MONTGOMERY COUNTY PLANNING DEPARTMENT
THE MARYLAND-NATIONAL CAPITAL PARK AND PLANNING COMMISSION

MEMORANDUM

REVIEW TYPE: **Site Plan Review**
CASE #: **820070060**
PROJECT NAME: **4901 Hampden Lane**

APPLYING FOR: Approval of up to 64 multi-family residential units, including a minimum of 15% (up to 10) moderately priced dwelling units (MPDUs), on 0.52 acres

Development Plan indicating Building Height Measuring Point

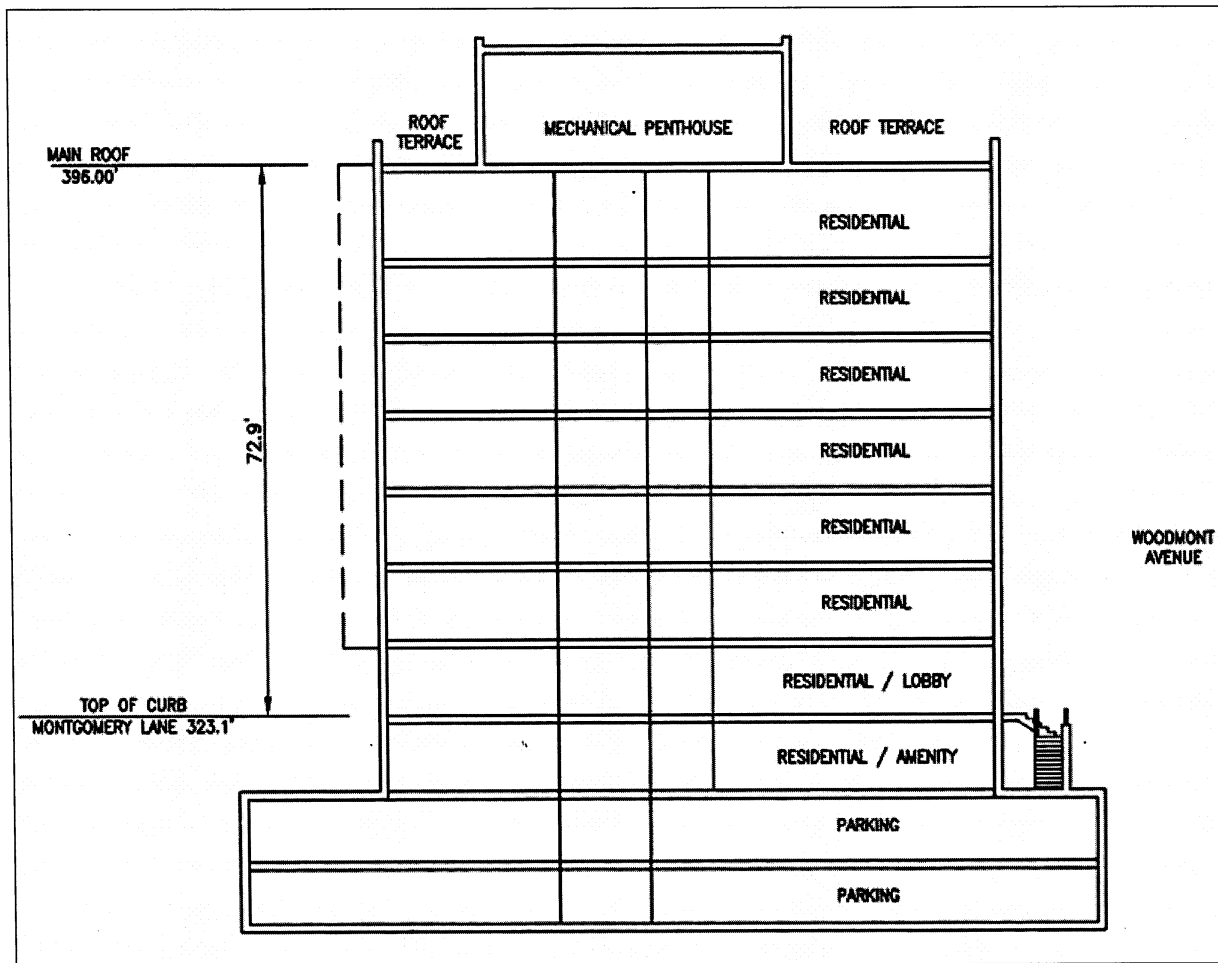
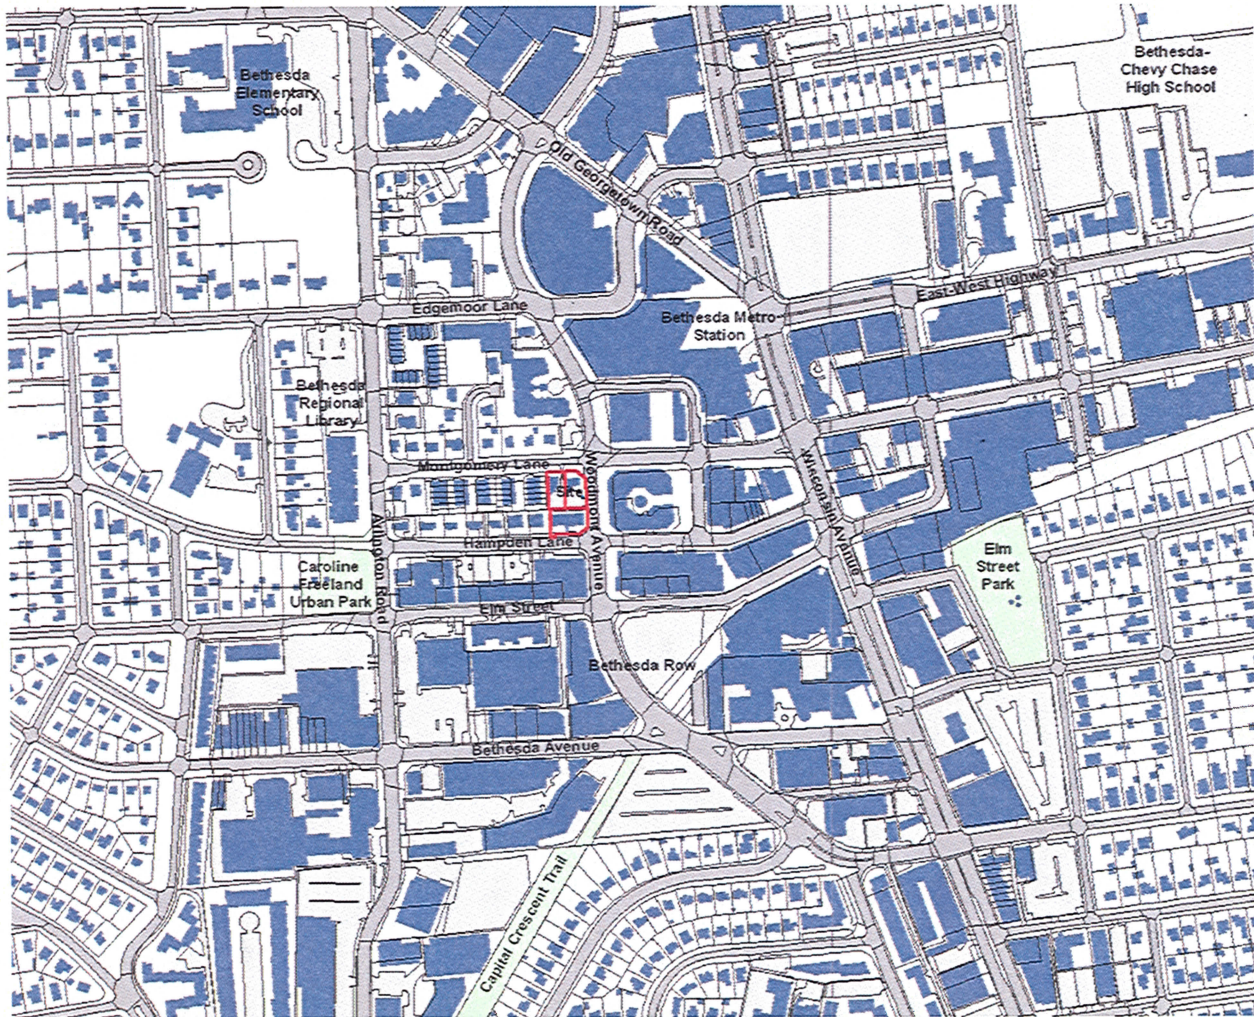
The approved building height, as documented in the Development Plan Binding Elements, is to be measured from elevation 326, the elevation of the northwest and southwest corners of the site. This also happens to be the elevation of the top landing of the entry stair at the main entry to the building, as indicated on the Development Plan (see exhibit on following page). From this point, a 70-foot tall building has a roof elevation of 396 feet. Height above sea level is not the method used by zoning, and thus by the Montgomery County Department of Permitting Services (DPS), to measure building height. For a through-block site on an end condition, such as exists at the subject site, the zoning allows the building height to be measured from the highest of the three curb heights surrounding the project. For this site, the Applicant has selected the curb height along Montgomery Lane, which happens to be located at 323.1 feet above sea level. Measuring from this point, as DPS will when they inspect the building for compliance with the approved Site Plan, the building is 72.9 feet, or 72 feet 11 inches, tall.

Resident associations of the developments to the west and north of the site have reviewed the proposal and have taken opposing positions on the issue of height. The Bethesda Civic Coalition (BCC) reiterates its support for the 70-foot building height in a letter dated April 23, 2007. Two other civic organizations, City Homes of Edgemoor and Concerned Families of City Homes, both representing residents of the City Homes development located immediately north of the proposed site on Montgomery Lane, expressed opposition to the proposed height. In their letter of March 2, 2007, in addition to other concerns (discussed later), the organizations explain that they prefer the building height not to exceed the 65 feet recommended by the Sector Plan.

Development Review and Community-Based Planning staff have reviewed the proposal and deem the 70-foot height to be in substantial compliance with the Bethesda CBD Sector Plan and compatible with the heights of the adjacent buildings. In order to account for any discrepancy in measurement method, staff recommends approval of a building up to 72.9 feet in height.
